PLANNING & INSPECTIONS DEPARTMENT CITY REVIEW COMMITTEE STAFF REPORT

Case No: PLRG26-00006
CRC Hearing Date: June 24, 2026
Case Manager: Alejandra González, 915-212-1506, GonzalezAG@elpasotexas.gov
Location: 937 Rim
Legal Description: Lot 8, Block 5, Rim Road Addition, City of El Paso, El Paso County, Texas
Acreage: 0.29 acres
Zoning District: R-3/NCO (Residential/Neighborhood Conservancy Overlay)
Existing Use: Vacant
Project Description: Construction of a new single-family residence
Property Owner: George Salom Jr.
Representative: Martina Lorey Architects

East Elevation

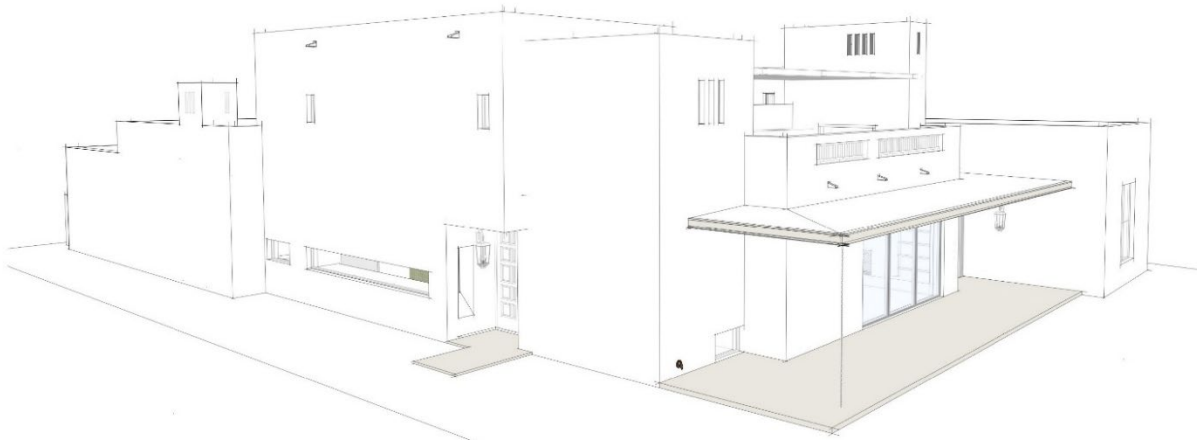
- (b) Site layout, scale and mass of new construction shall be generally compatible with existing development in the same block.
The proposed development is compatible with the site layout, scale, and volumetric mass of the existing developments in the same block.

The applicant's proposed thirty-foot (30') front yard setback is more than the twenty-five-foot (25') traditional front yard setback on this block.

The proposed construction will have the garage at the rear.

The proposed design complies with this standard. The only paved areas located within the front yard are the driveway along the southern edge of the property and the pedestrian pathway leading from the street to the front entrance.

EXTERIOR FINISH KEY

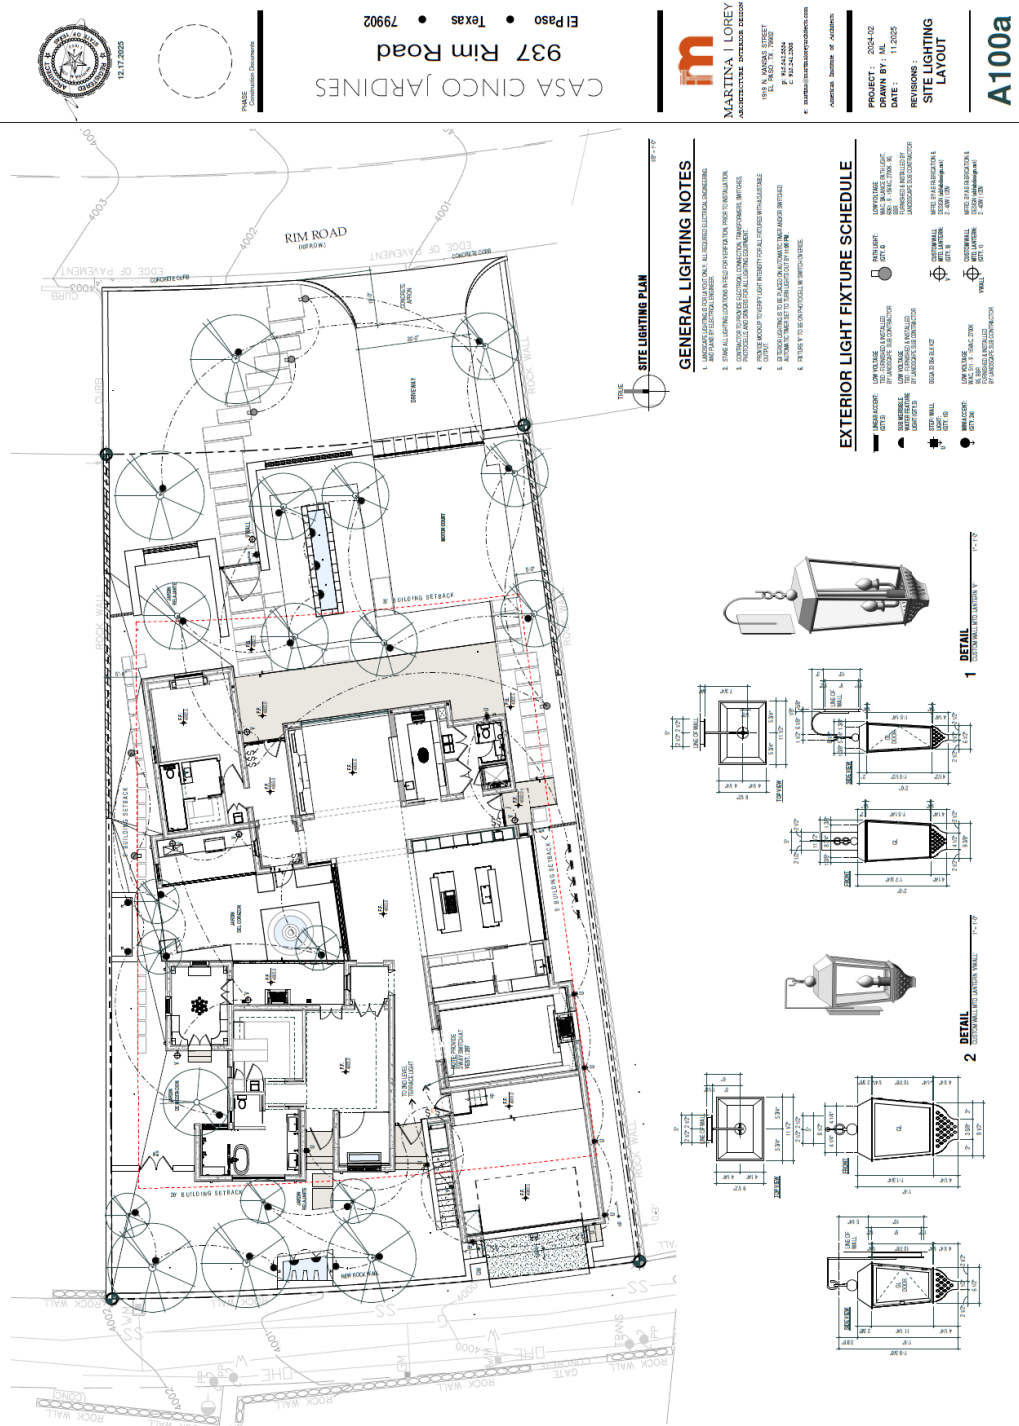
The proposed fencing complies with this standard. The custom-fabricated steel gates feature a pattern that mimics breeze brick wall panels and are finished in a bronze coating, complementing the architectural style of the main residence.

None of the proposed materials will feature reflective metallic or fluorescent finishes, utilizing instead a neutral palette.
